SUMMARY OF CONSTRUCTABILITY REVIEW MEETINGS

C-2 – New bridge construction and grade & pave from east of South Expressway to Madison Ave.

Meeting Summary – May 18, 2015

Contract C-2
Council Bluffs Interstate System - Segment 3

CONTRACT C-2 CONSTRUCTION OVERVIEW

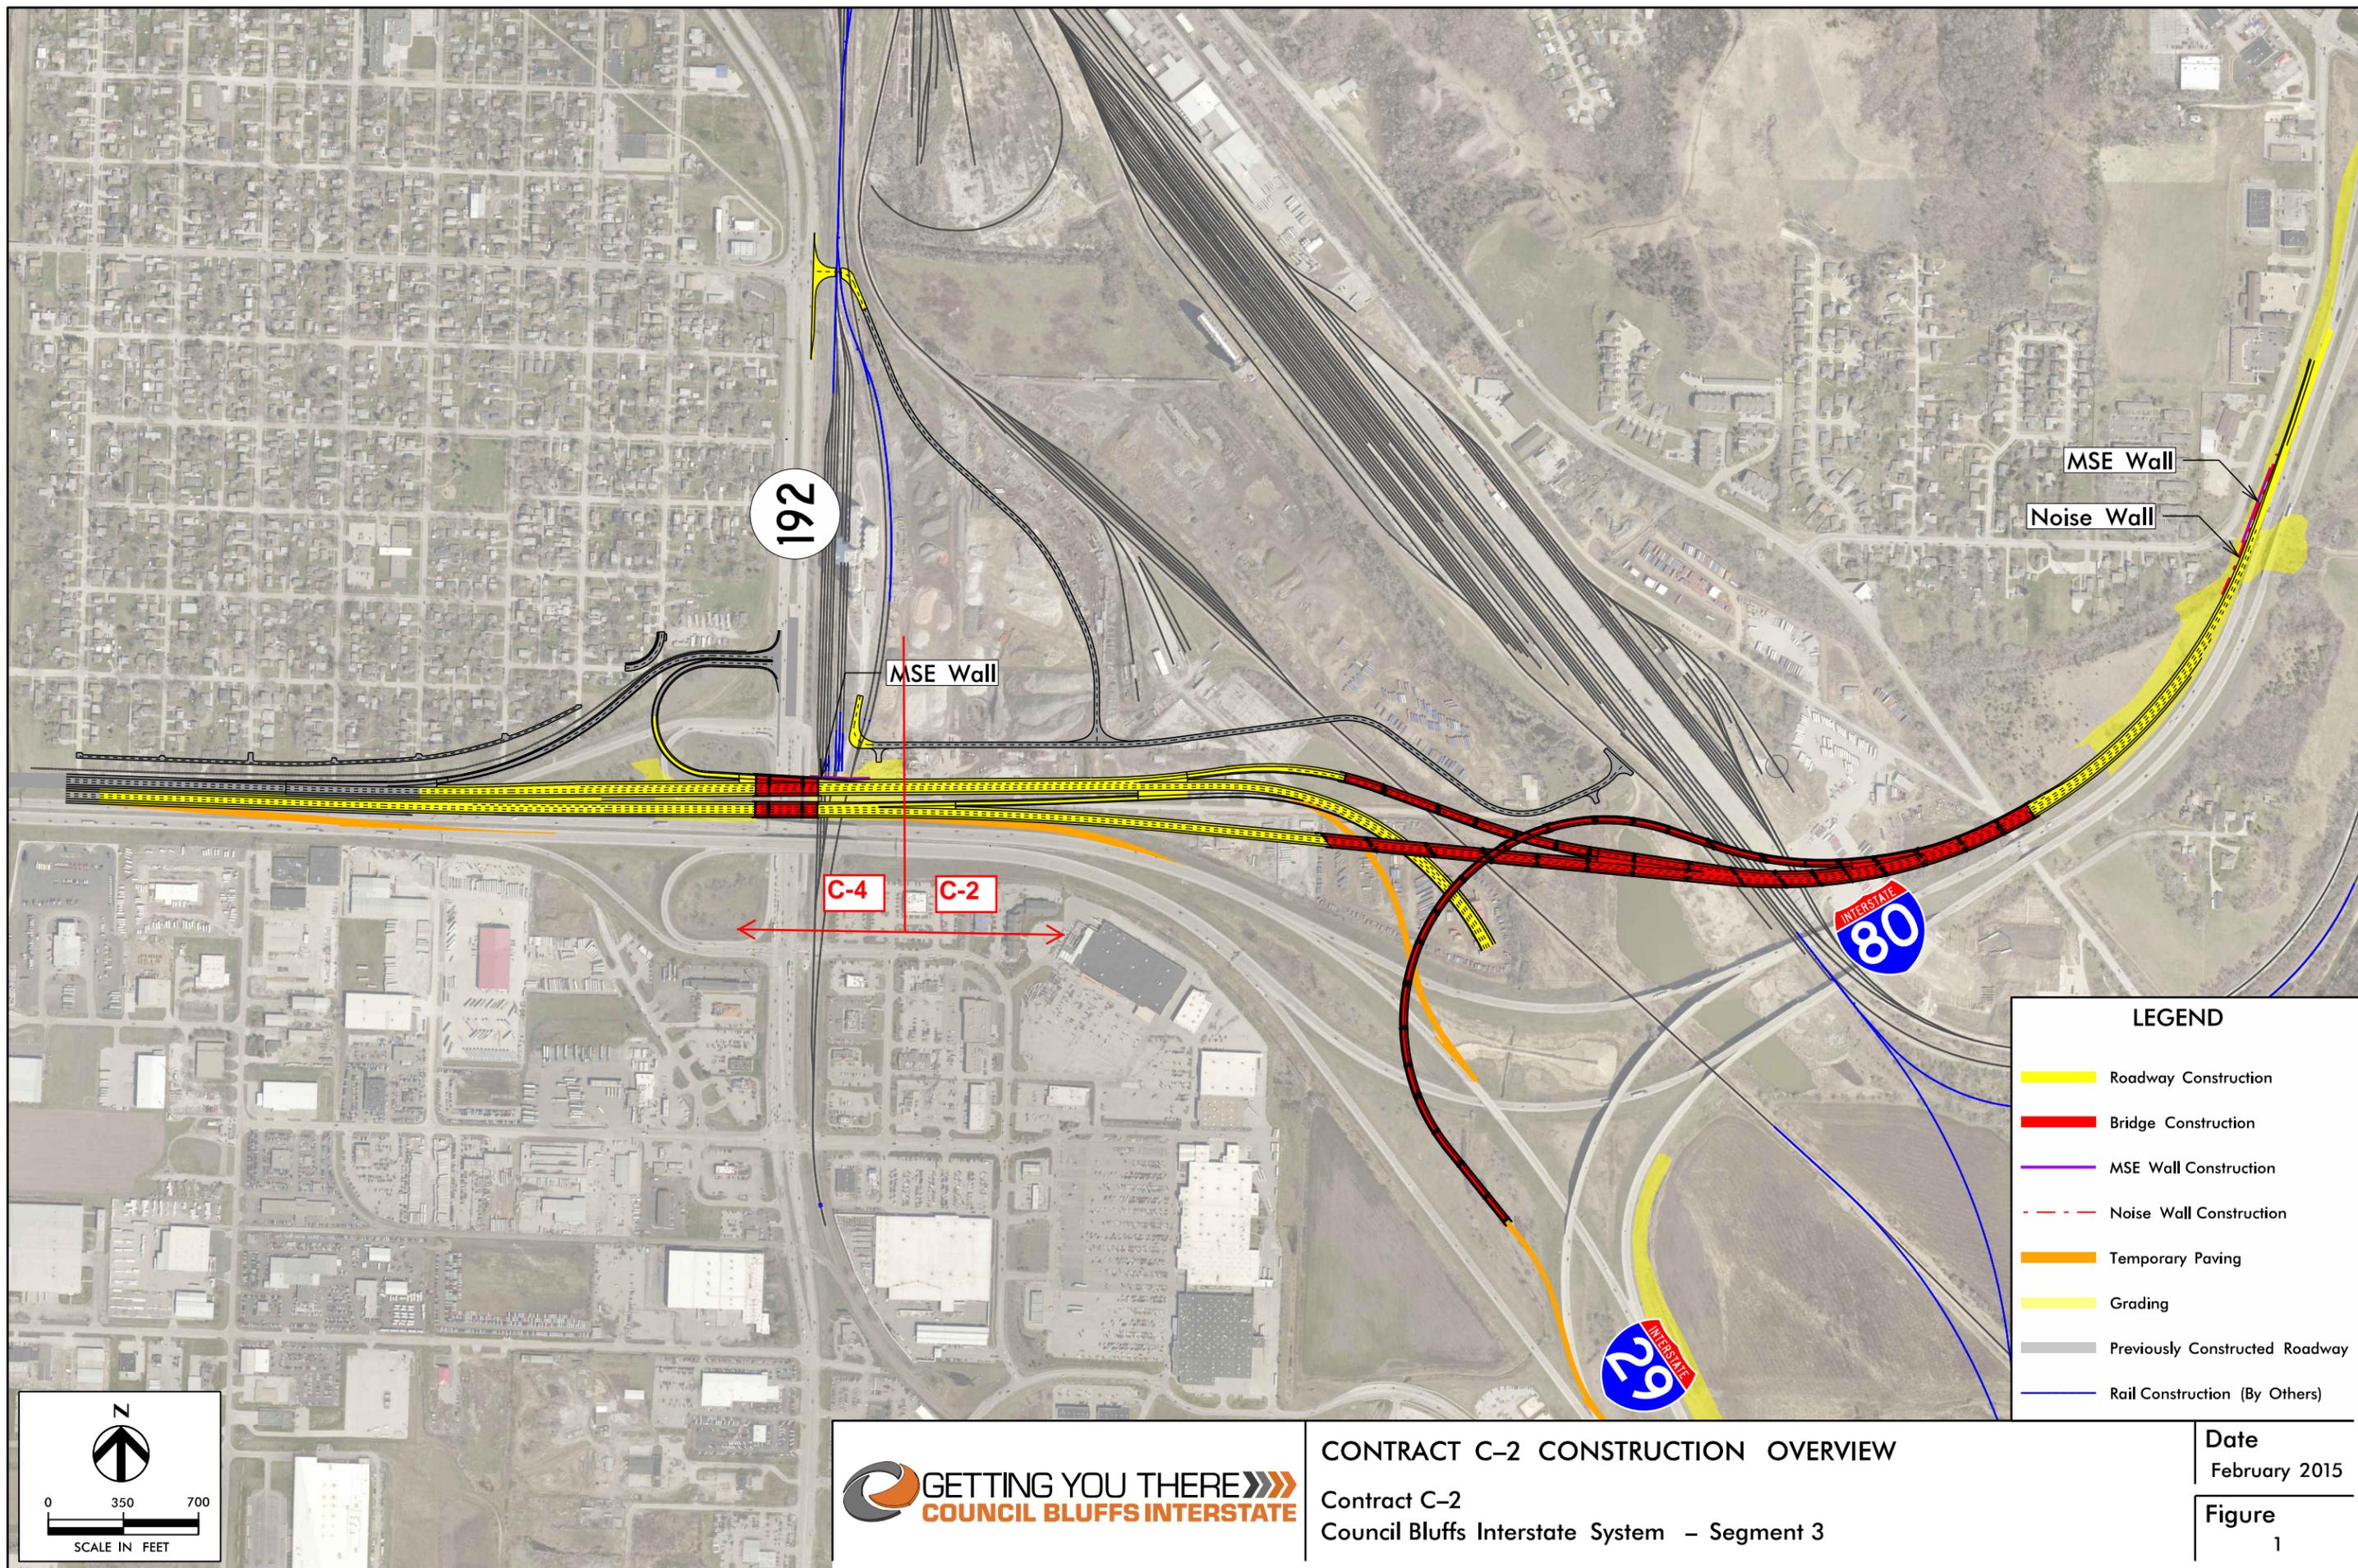
- » Does IAIS use the last 150' of track on the west side of yard? It would be beneficial to temporarily close a portion of the tracks to speed up construction and open up access to piers 16G, 8WB, and 9EB.

- » Can materials be swung over the tracks on the west side of the yard for the west pier line?
 - › This would have to be done in coordination with the railroad and applicable flagging requirements.

- » Can a temp crossing be built for girder placement? Would be better to have a temp crossing between piers for girder placement, rather than walking girders in on cranes

- » Can the EB Bridge (girders) be built in the rail yard? Building the WB viaduct bridge will limit access to the EB Viaduct superstructure that will be built in a future D-2 contract. If girders in the rail yard are not set for EB, then girder placement will be difficult. Crane reach will be limited

- » Ramp G construction access will be challenging with the slopes in and around the existing roadway embankments. The plans should also include an access plan.

- › **Note: A subsequent discussion with IAIS RR indicated that the two stub tracks will be connected to the BNSF tracks/turn-outs south of the project area by the end of 2015. So abandoning these track stubs may not be an option.

- › IAIS later indicated that there is opportunity to construct crossings of the westernmost track; interruptions are 2-3 times per day with an approximate 15-minute duration.

- IAIS RR has indicated that the railroad would construct the temp crossings.
 - › Maybe consider a crossing that could be moved within a 4-hour window
